## **Scoping Statement**

### **Environmental Impact Assessment (EIA), , on lifetime extension Loviisa 1&2**

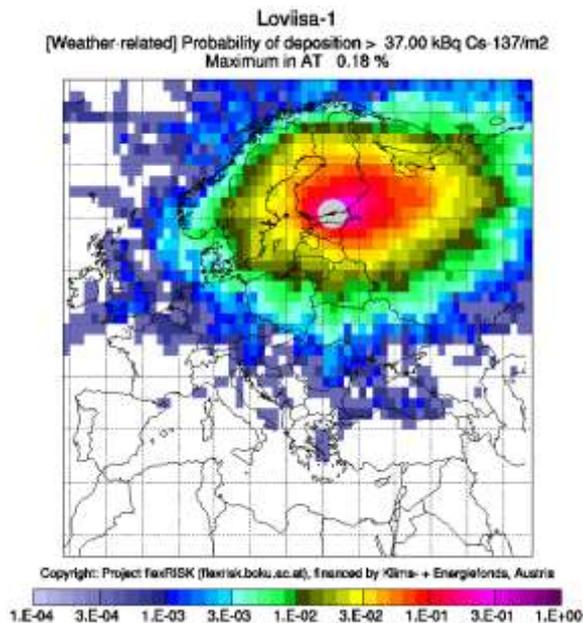
The following flexRISK figure shows the weather-related risk for Europe to be contaminated with Cs-137 above 37 KiloBecquerel Cs-137 per m<sup>2</sup> in case of such an accident happening.

**Under unfortunate weather conditions, almost every country in Europe could suffer such a high Caesium contamination.,**

The EIA Report shall also include accident calculations with the highest source term for which the risk is not zero, and dispersion calculations for all of Europe.
